KLAWOCK AIRPORT

RUNWAY, TAXIWAY AND APRON IMPROVEMENTS

PROJECT NO. 68164
DTFAWA-06-A-00013

ADD. 3

REVISIONS			PROJECT DESIGNATION		YEAR	SHEET NO.	TOTAL SHEETS
NO.	DATE	DESCRIPTION					
			DTFAWA-06-A-00013		2007	B2	27

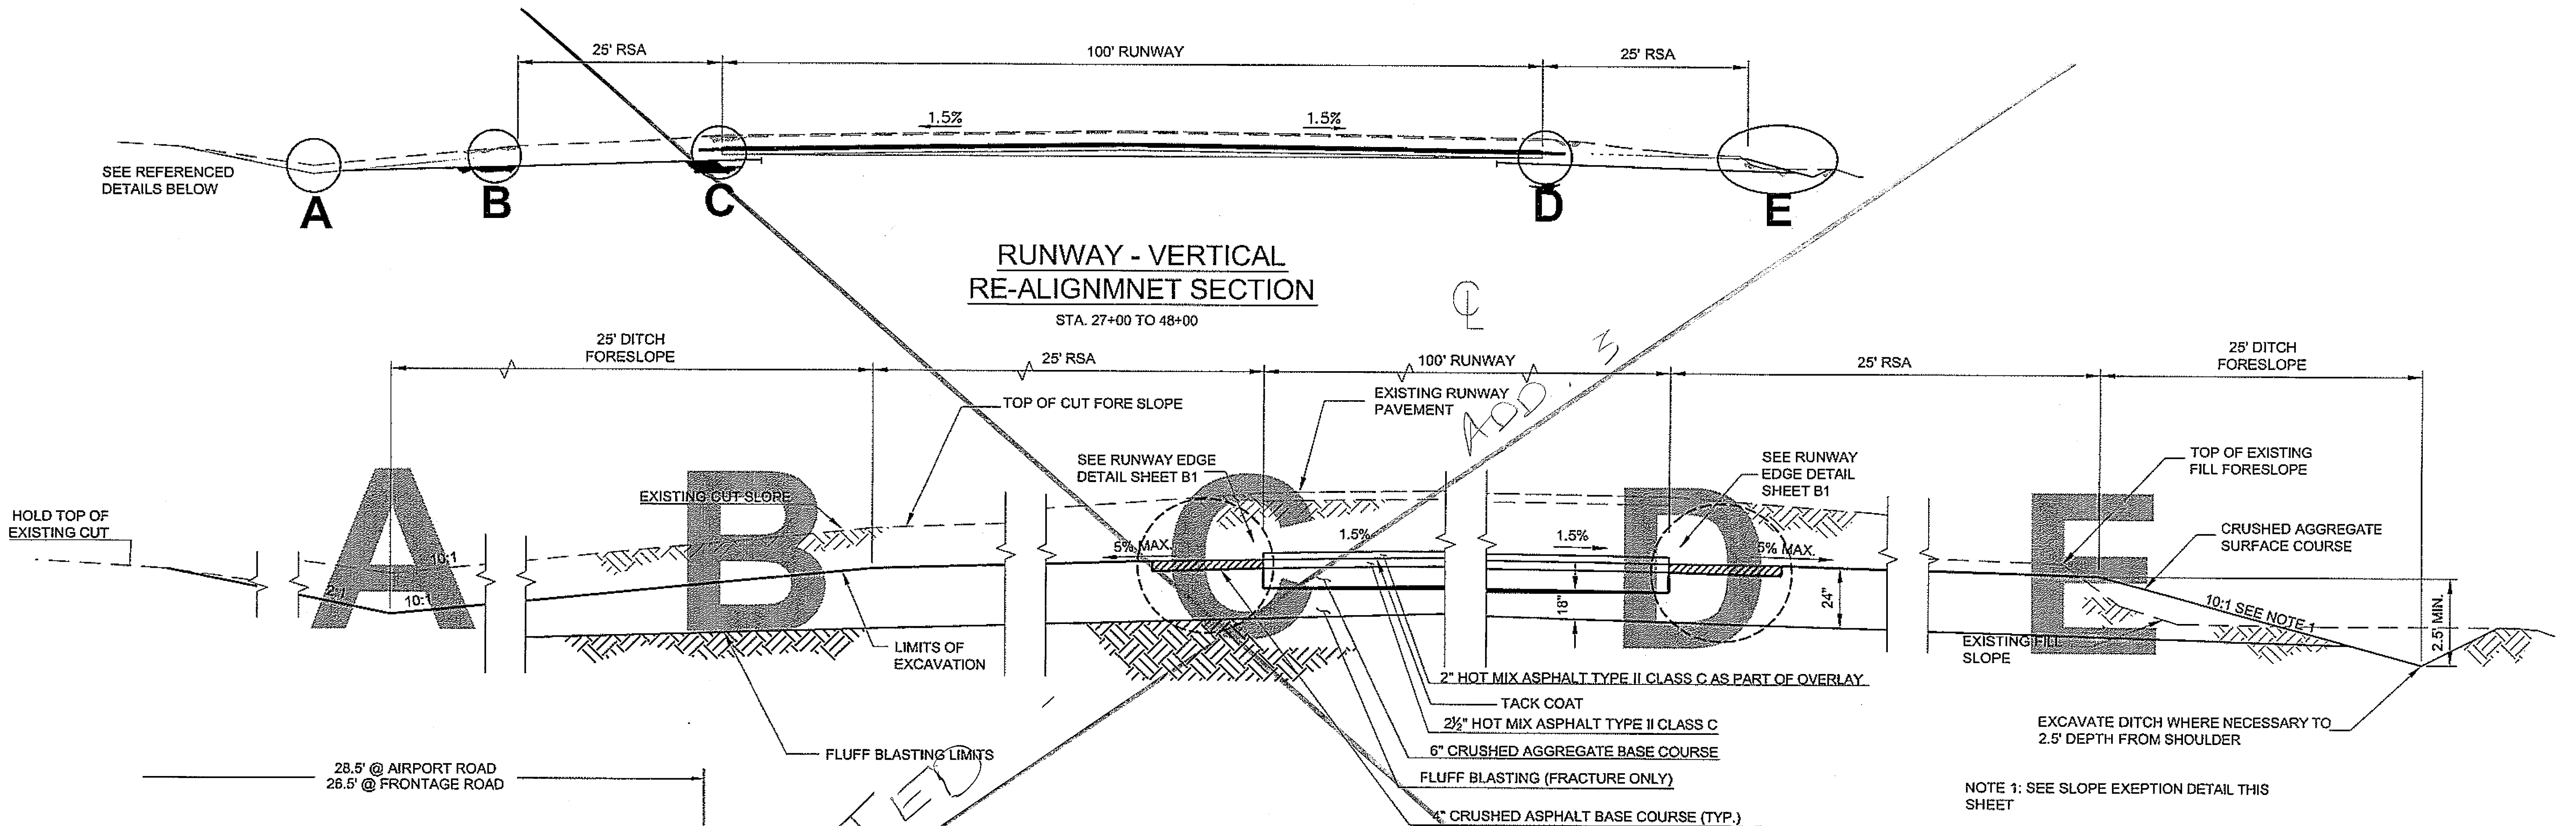
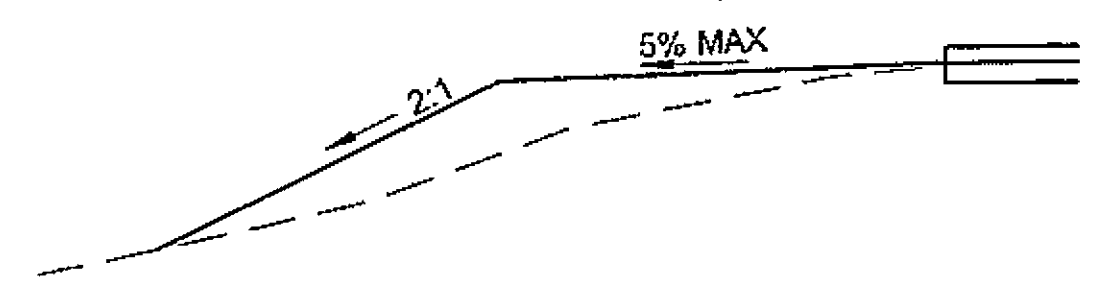
Sheet B2 Add the following callout to the area outside the 100' Runway and above the Limits of Excavation that is not Crushed Asphalt Base Course on the Vertical Re-Alignment Details Sta. 31+00 to 43+00: "Crushed Aggregate Surface Course (Typ.)"

AUTOMATIC GATE TRANSITION TYPICAL

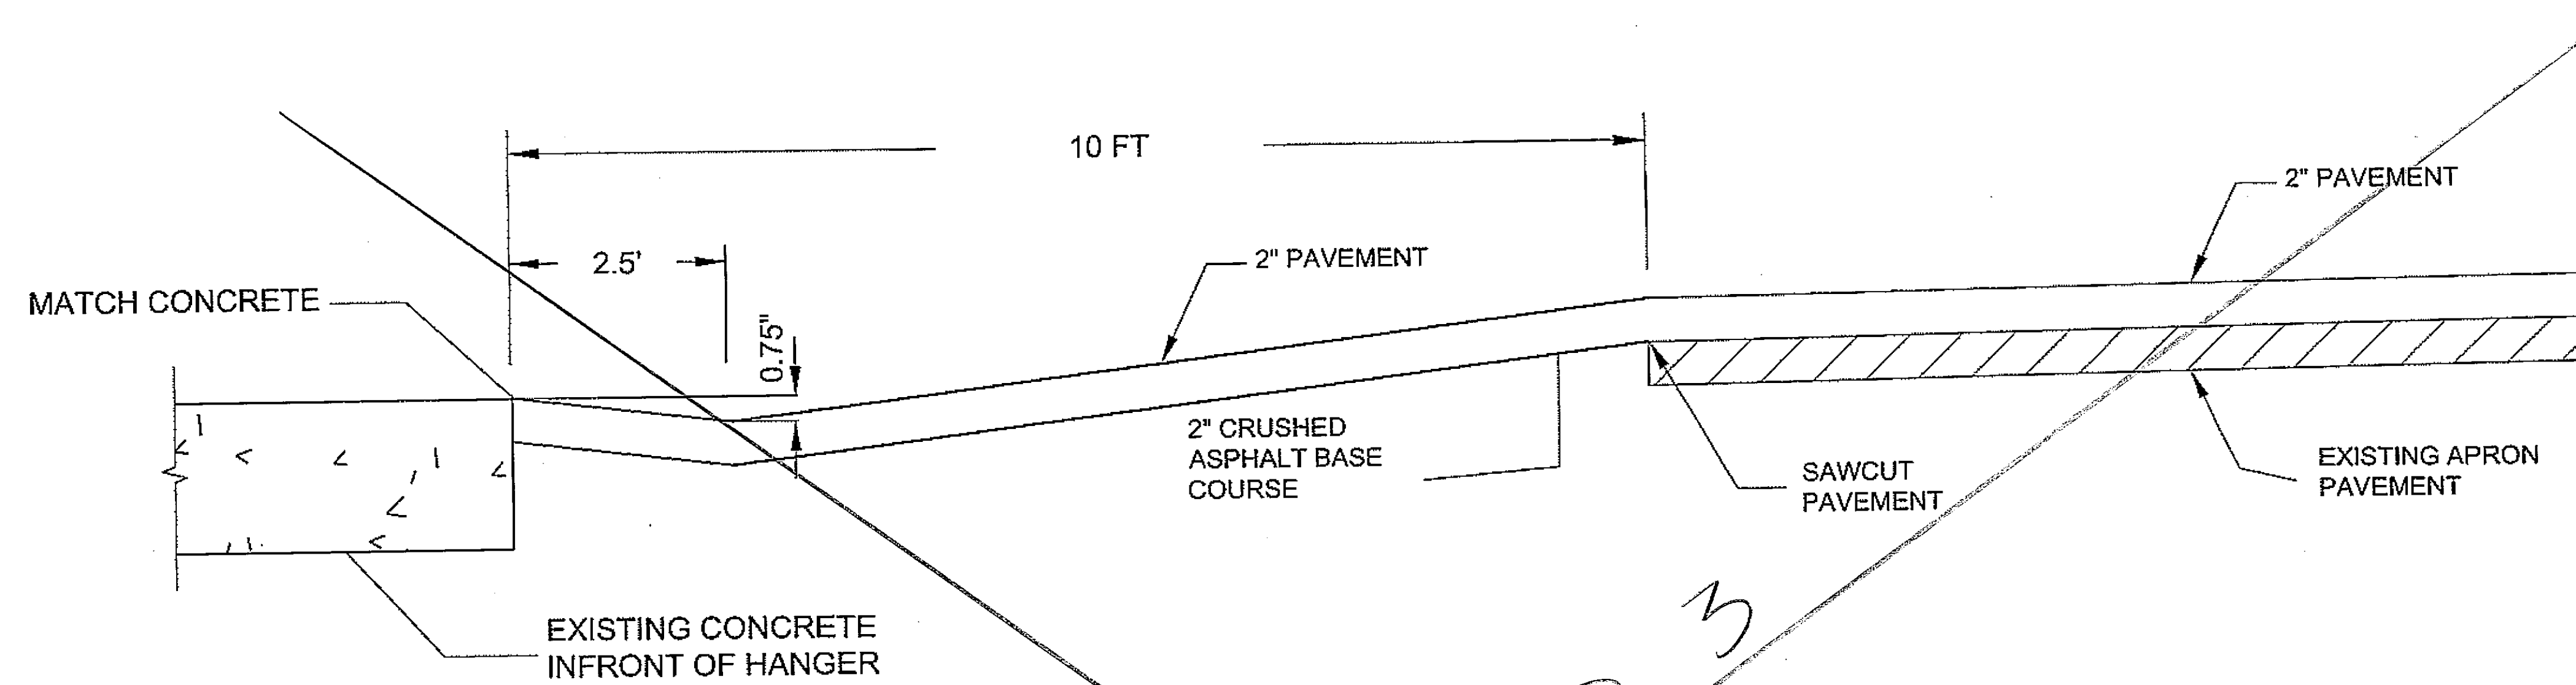
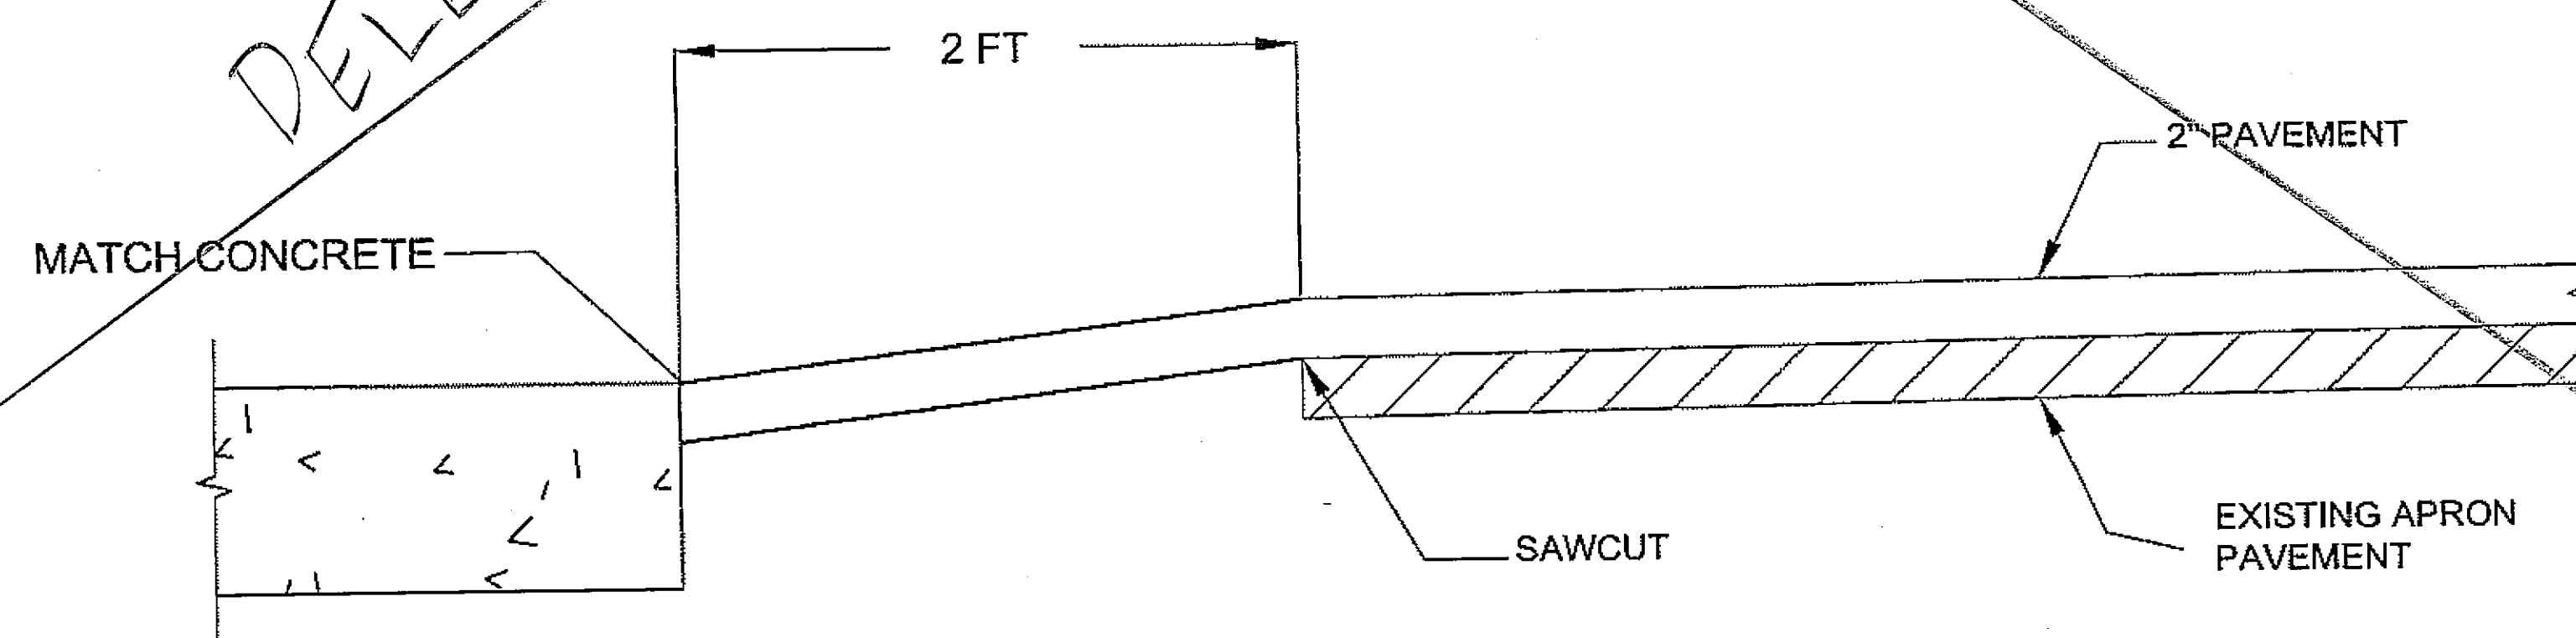
DELETED

ADD. 3
